Summary of Early Design Guidance .....13

Design Responses.....31

Property Address: 1405 S Bayview, Seattle, WA 98144	
Owner:	BIHI, LLC
Developer:	Tim Abell, Principal Pacific Housing NW LLC 229 Broadway E. Seattle. WA 981012
Architect:	Weinstein A+U LLC Matthew Zinski T (206) 443-8606
Landscape:	Karen Kiest Landscape Architects Karen Kiest

LEVEL 2 FLOOR PLAN

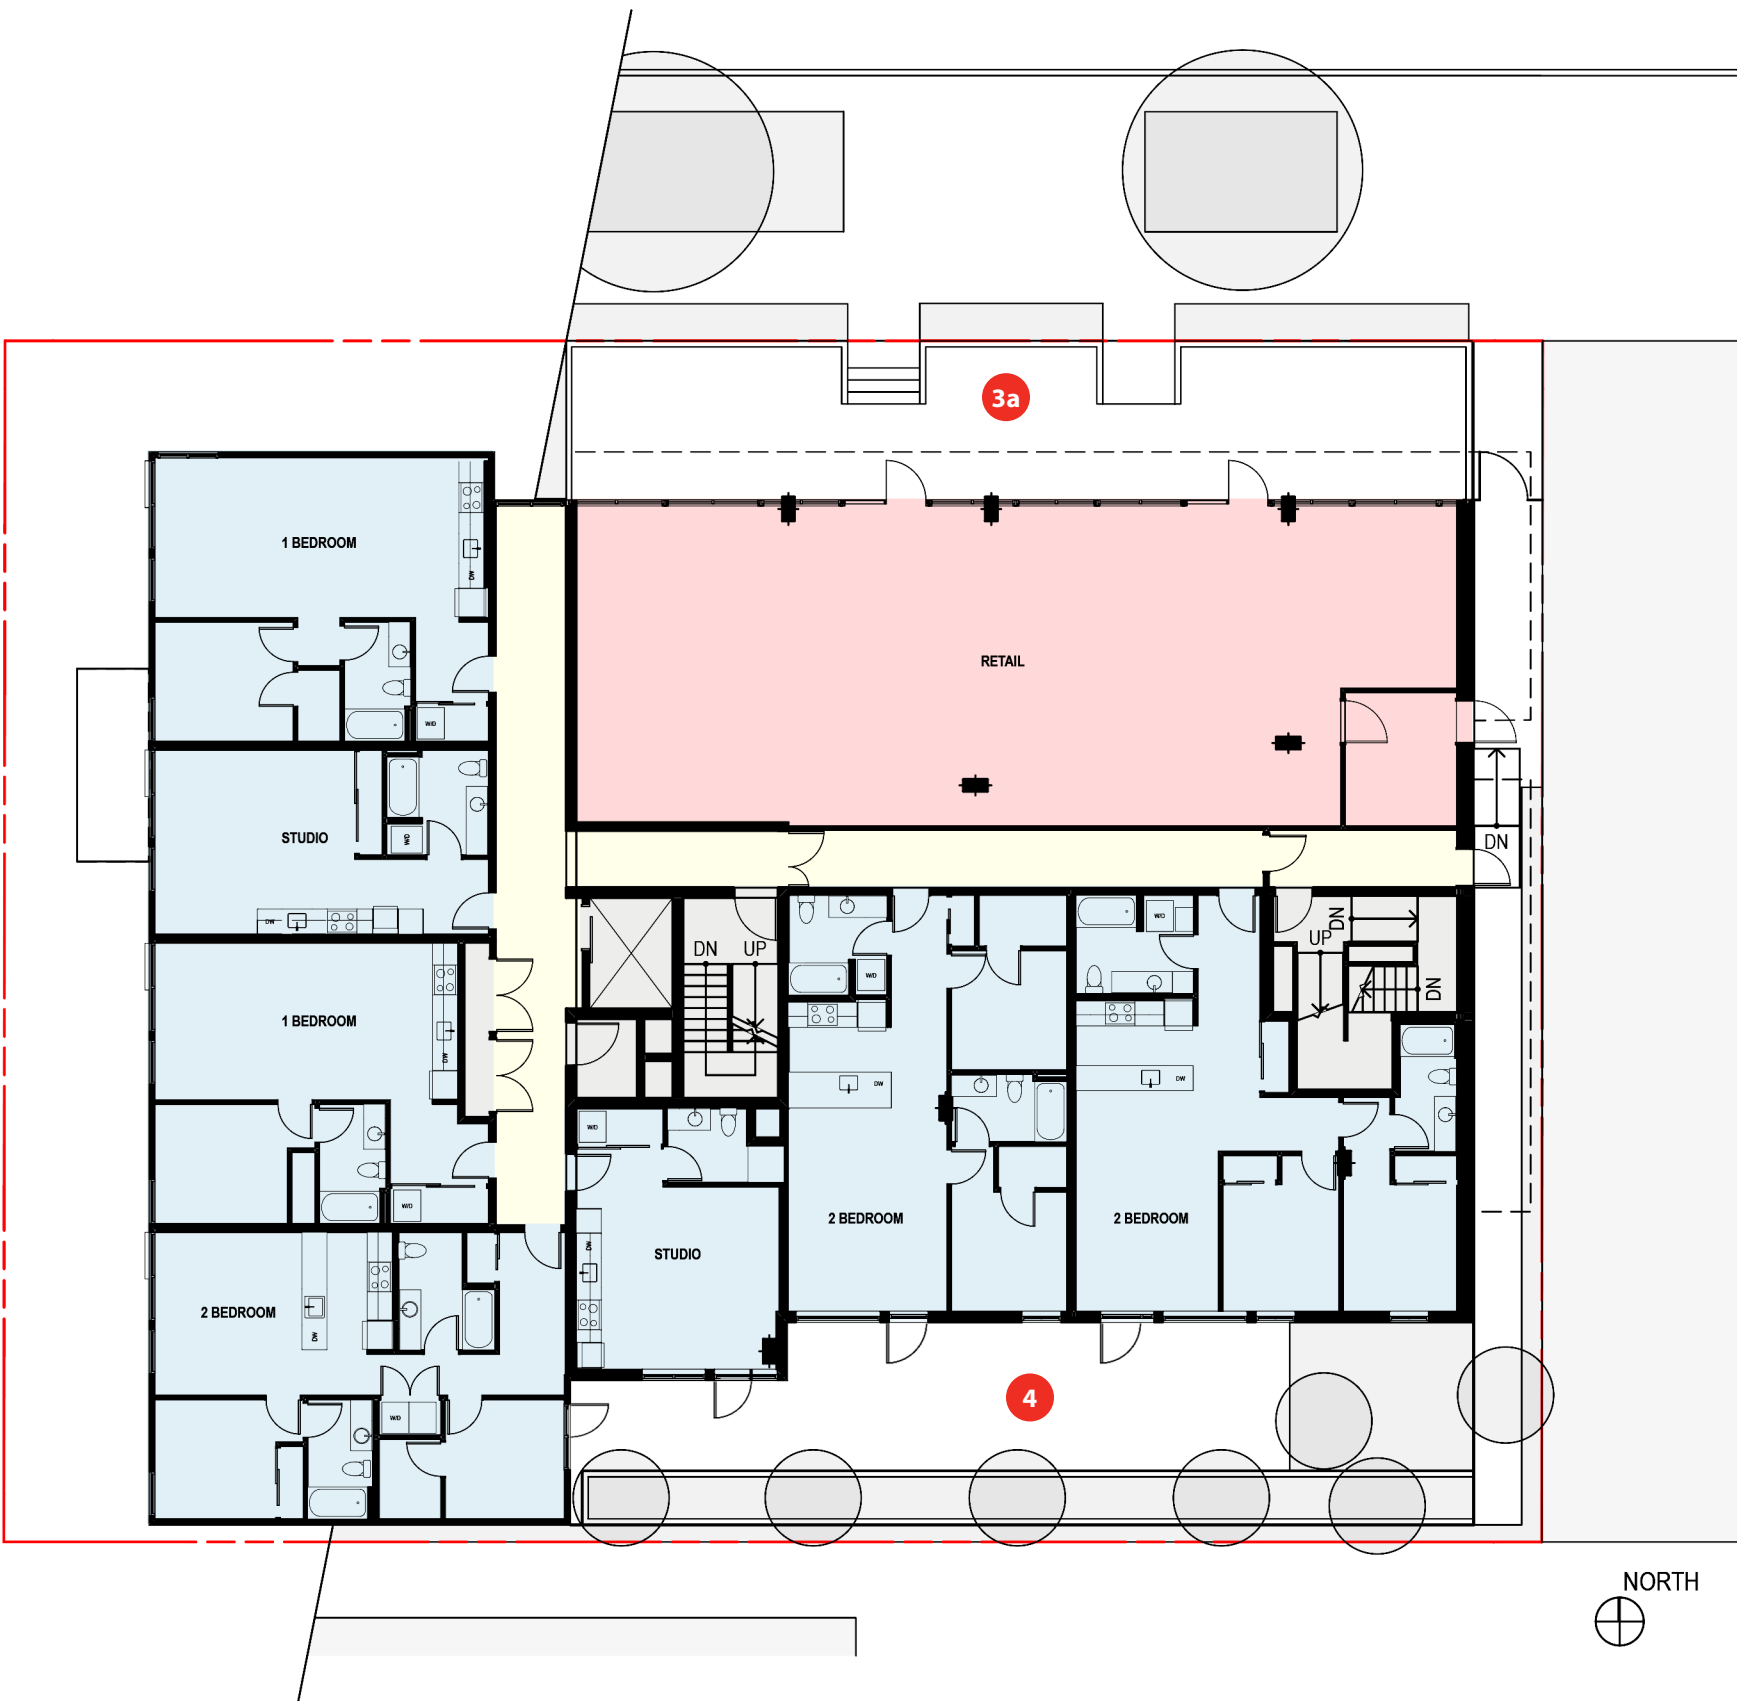
Commercial Zone

- 3a** The retail plaza has been expanded from the previous 6-foot depth to approximately 13-feet to better accommodate outdoor, retail activity.
- 3d** The mountain-to-island landscape strategy assists in the street-level transition from commercial to residential. The landscaping is taller, denser, and heavier - representing the mountain - adjacent to the retail area. The landscaping scale and texture transitions in scale and texture as it moves down the hill to the residential program on 14th Ave S.

- 4** The units along the south courtyard have been designed 2-bedroom units with small families in mind but as a result of the expanded retail plaza, the south courtyard has been reduced in size. Each unit is still provided access to a private patio space and plantings. The bioretention planter along the south property line mitigates stormwater but also provides privacy and security to the residential units.

## NORTH ELEVATION (S BAYVIEW STREET)

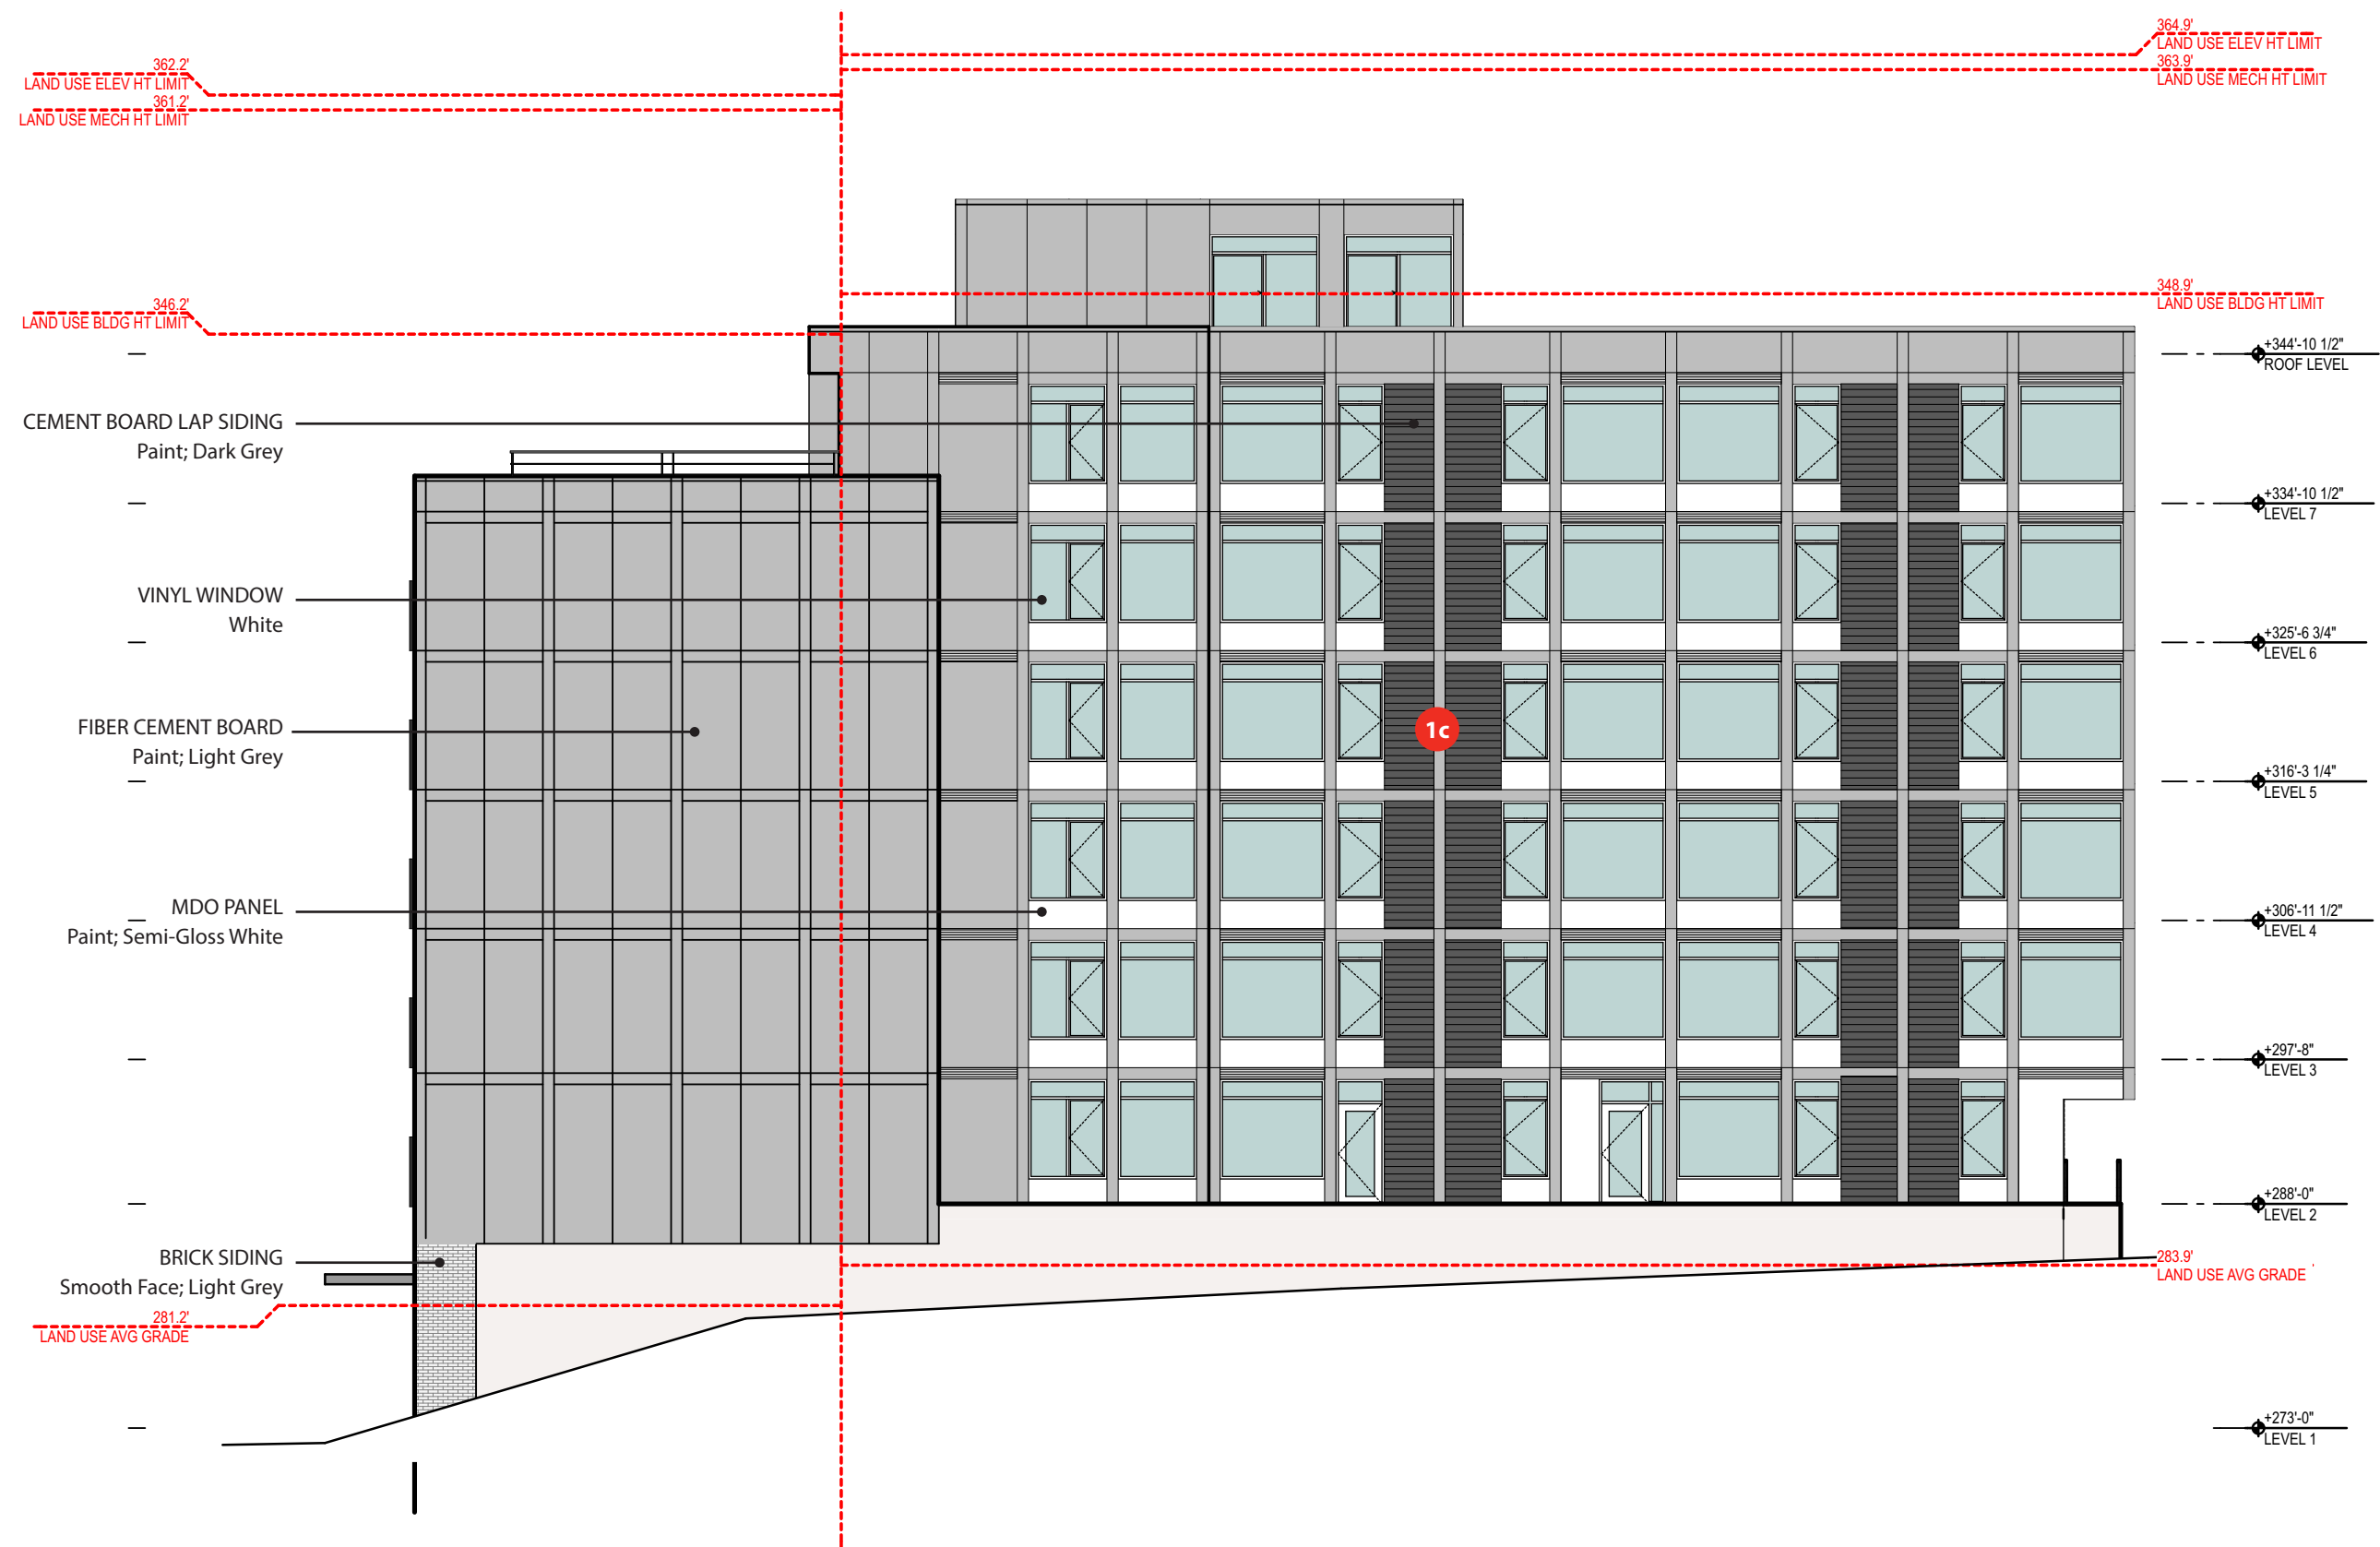
Massing and Context Response

**1b** In consideration of the zone and scale transition to the south and east, this proposal has reduced the actual and perceived scale. The building has been reduced in height by 1-story. In addition to a reduced mass, the project thoughtfully scales the facade. Dividing the facade into a base and top reduces the perception of height and mass. Organizing the facade into a grid with material transitions reduces the perceived scale. Adding secondary elements like wood balconettes and an entry canopy provides human scaled texture and shadow lines.

**1c** he proposed design has been further articulated with a clear facade organization, material application, and secondary elements.

**3c** The scale of the retail plaza and storefront has been reduced. The storefront height has been reduced by several feet. The retail edge of the retail plaza interfacing with the sidewalk is buffered by landscaping and protected by a transparent railing.

SOUTH ELEVATION

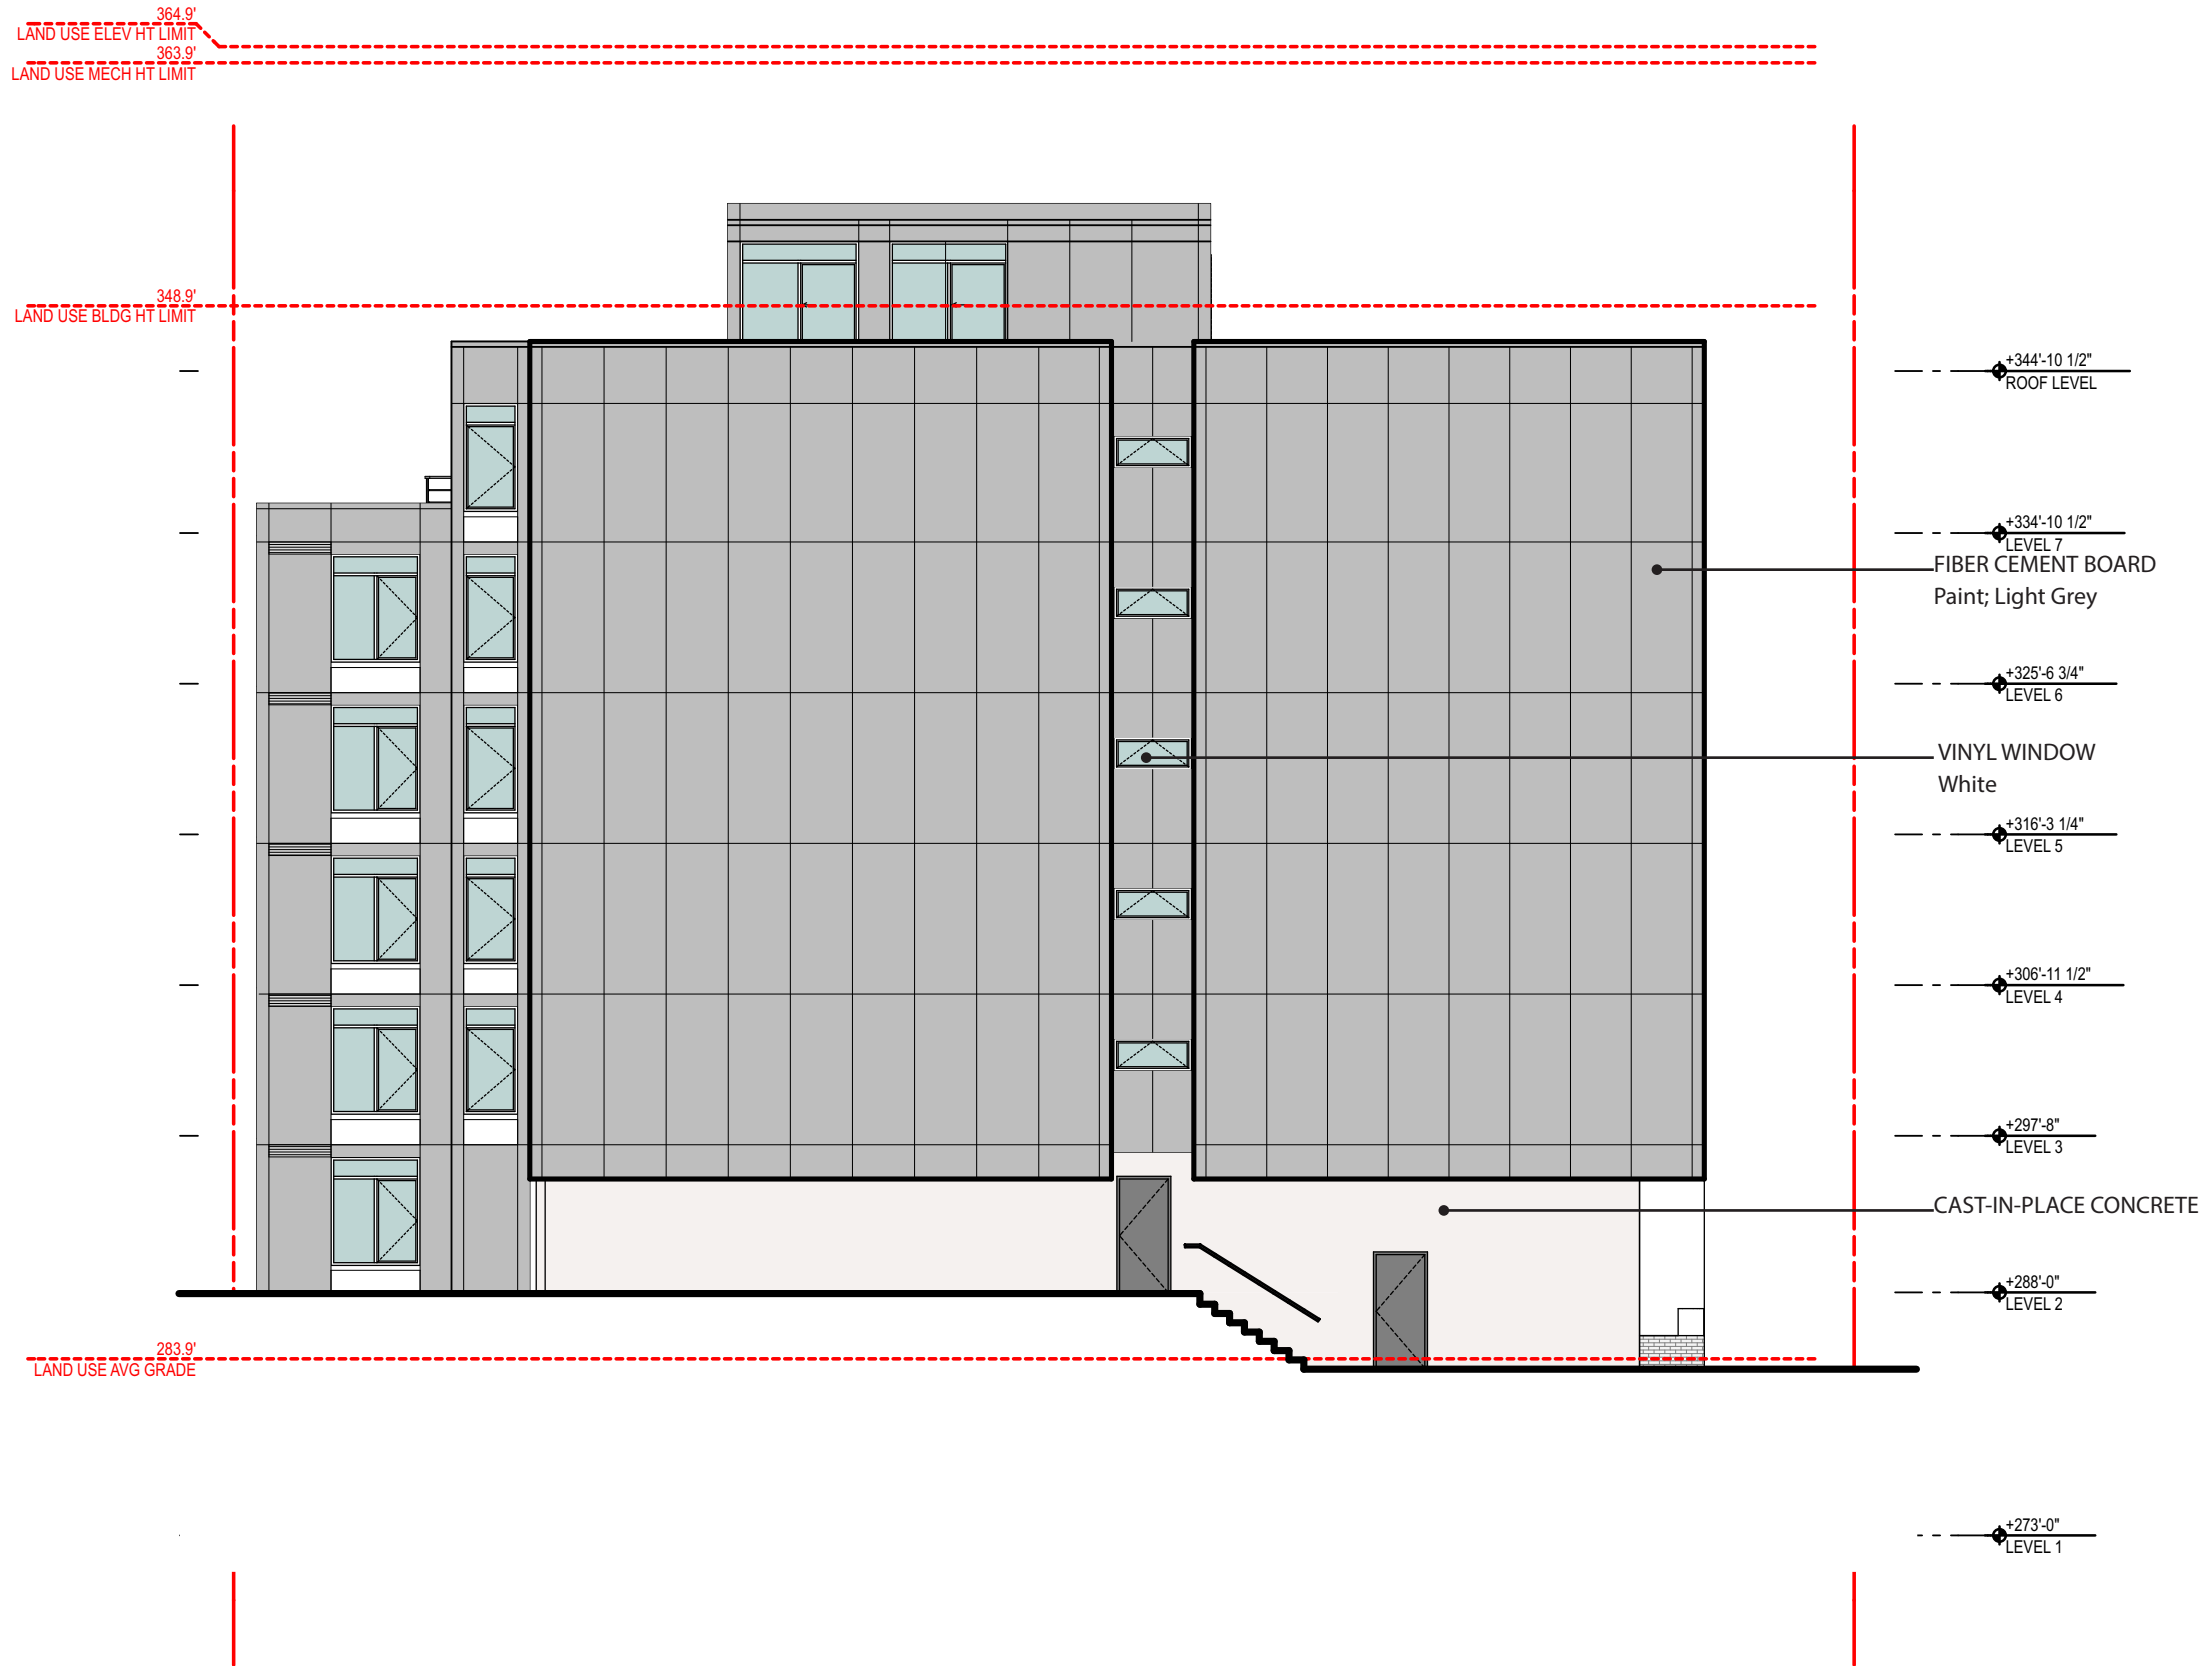
Massing and Context Response

**1c** he proposed design has been further articulated with a clear facade organization, material application, and secondary elements.
